# FCA 6026/7 & FCA 7043/4 also FSK 6109 & FSK 7646

Vauxhall/Opel

*Corsa II/Corsa B, Tigra (2000 on)*

New version (swaged bush)

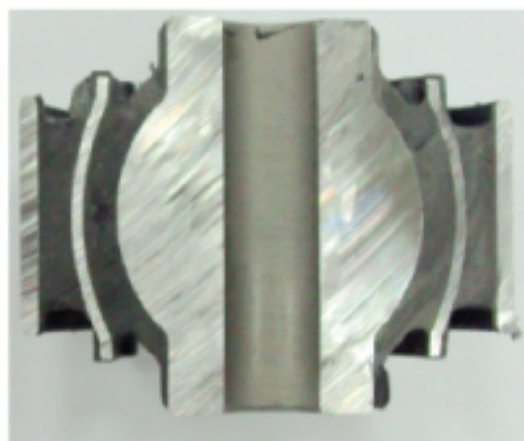
The Original Equipment specification of the rear wishbone bush has been upgraded with enhancements to its construction. The bush now has a swaged design to further improve its service life.

The swaged bush provides a greater bonding area for the rubber, which directly increases the overall longevity.

FCA6026/7

Original design

FCA7043/4

New improved design
